**THIRD RESPONSE TO REQUEST FOR ADDITIONAL INFORMATION
PERMIT TO OPERATE COMPOSTING FACILITY
PERMIT TO CONSTRUCT LEACHATE TREATMENT FACILITY
PERMIT TO OPERATE RESOURCE RECOVERY FACILITY
WASTE TIRE GENERAL PERMIT
AND
PERMIT TO MAINTAIN CLOSED CLASS I SANITARY LANDFILL
PREPARED FOR**

**BOARD OF COUNTY COMMISSIONERS
DEPARTMENT OF PUBLIC WORKS
222 EAST McCOLLUM AVENUE
BUSHNELL, FLORIDA 33513**

October 2, 1992

RE: SUMTER COUNTY SOLID WASTE FACILITIES
PERMIT NO.:

CROSS SECTION "A-A"

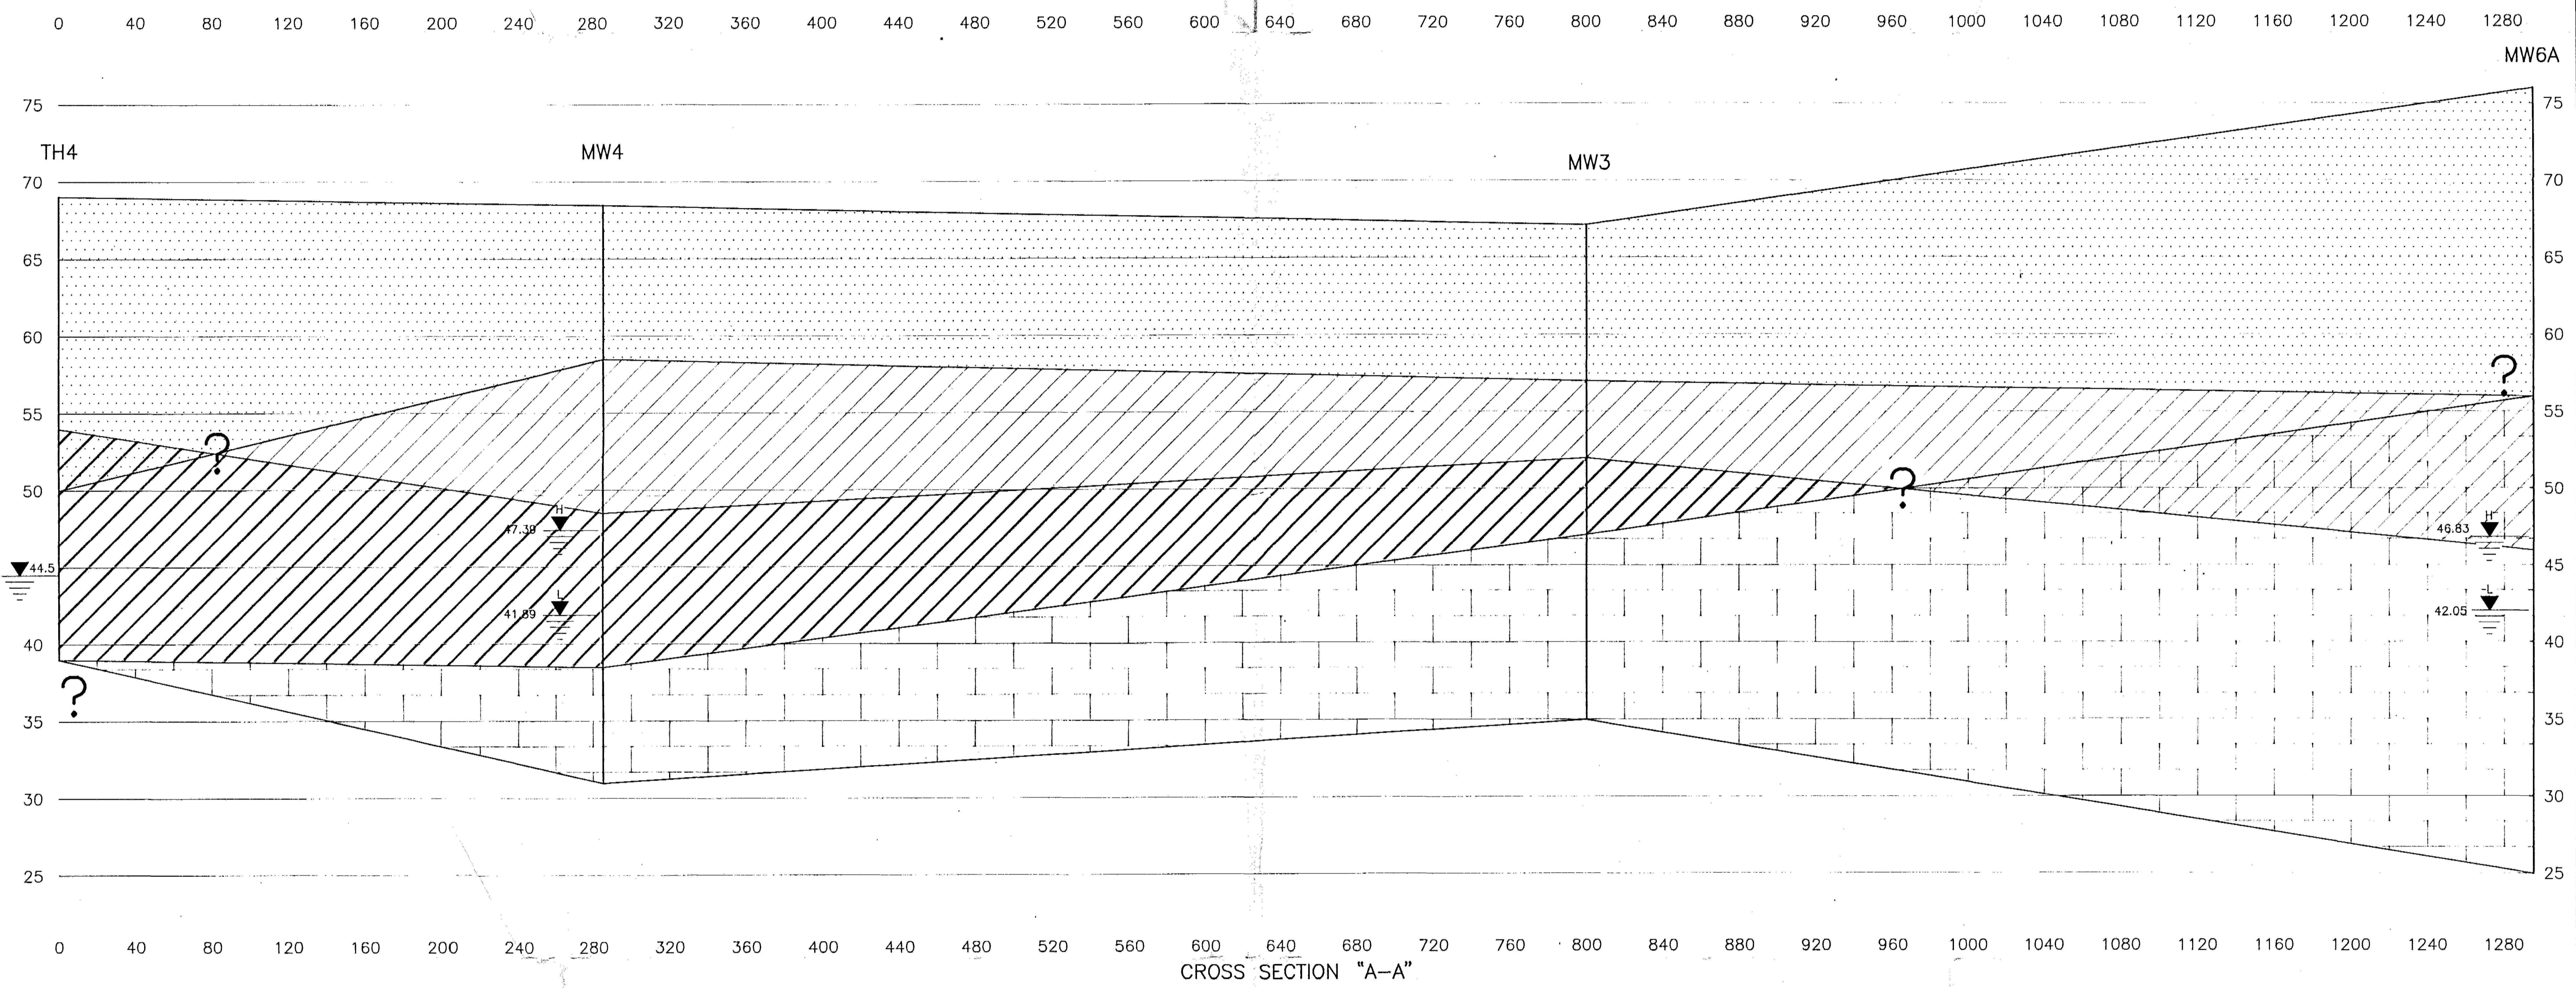
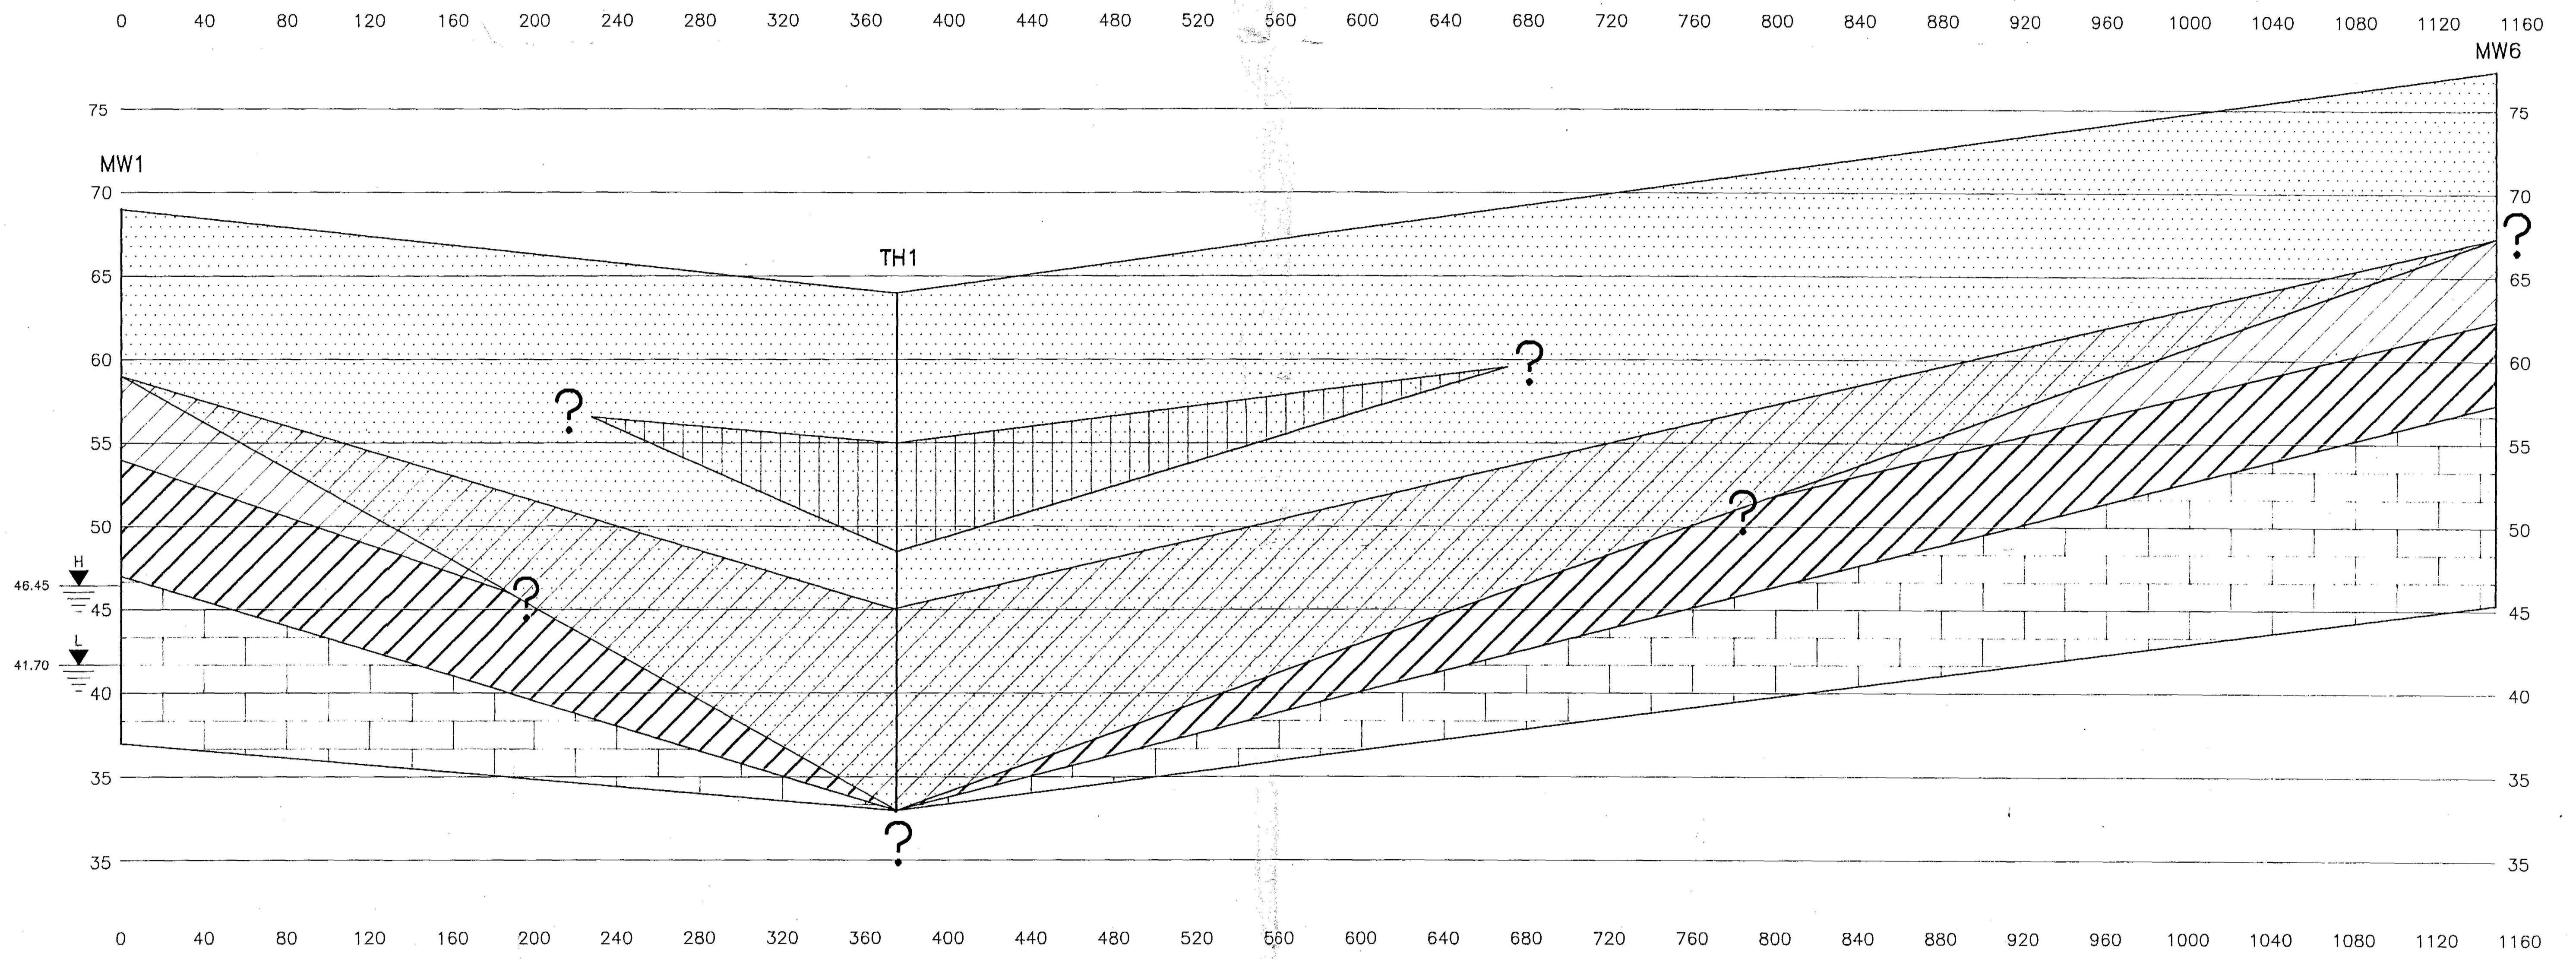
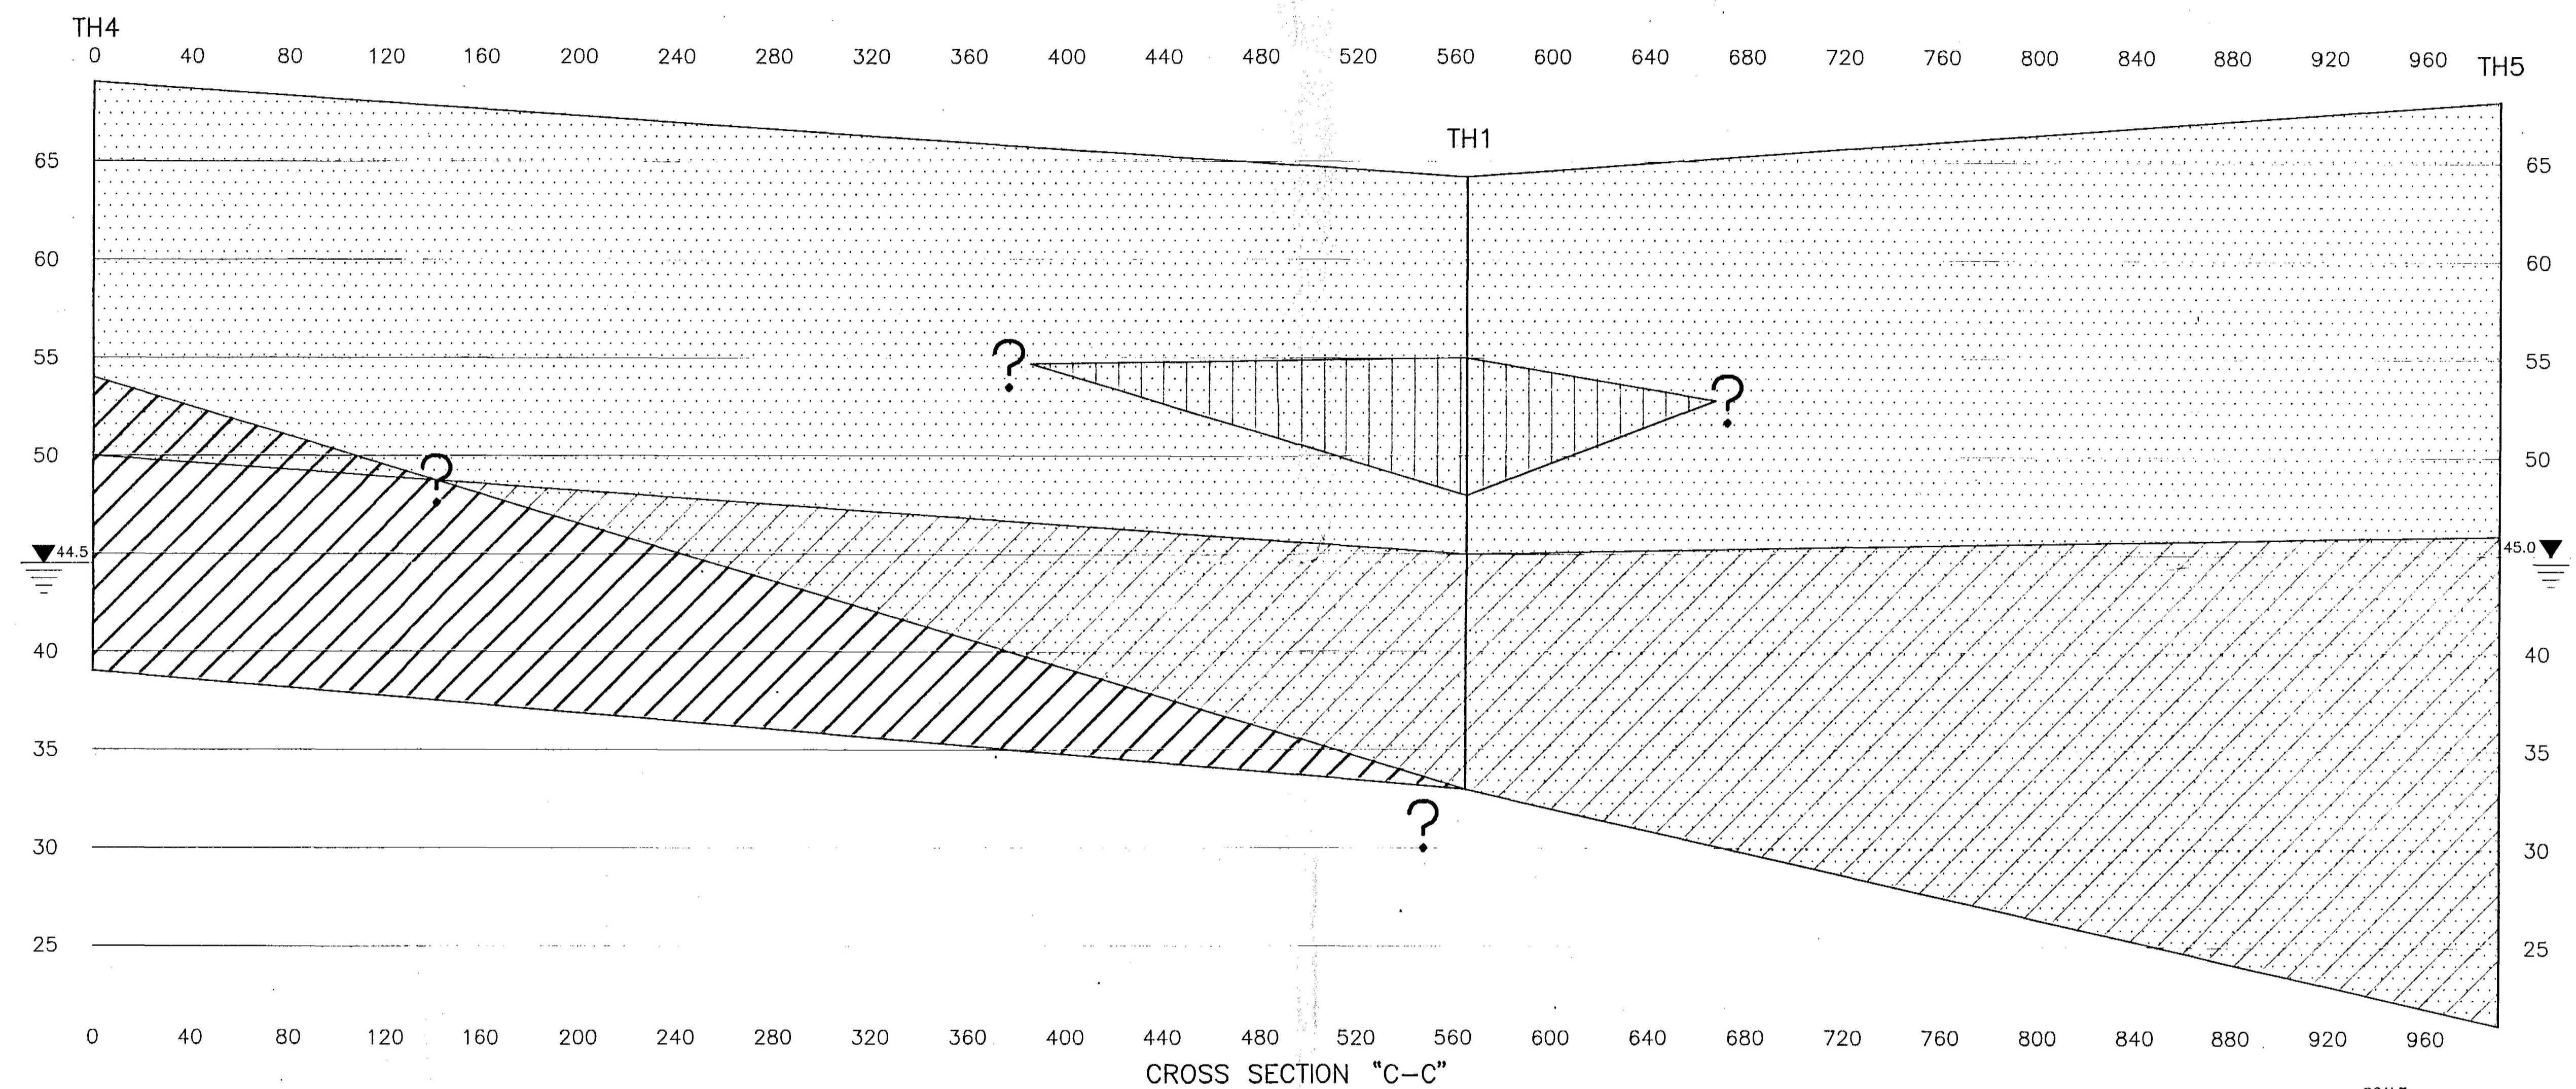
- 3.6. The water table should be illustrated on the cross-sections. The most recent seasonal high and low water table as measured from the monitor wells should be used.

- 3.5. General cross-sections have been prepared and are enclosed in Appendix C. The borings denoted by the "TH" prefix were performed by drillers specializing in foundation engineering. These logs contain more detailed information than the logs prepared from data obtained from the monitor well completion reports.

- 3.6. The highest and lowest groundwater elevations encountered during sampling events for the monitoring wells for the period beginning January 8, 1991 and ending April 7, 1992 are shown on the general cross-sections presented in Appendix C.
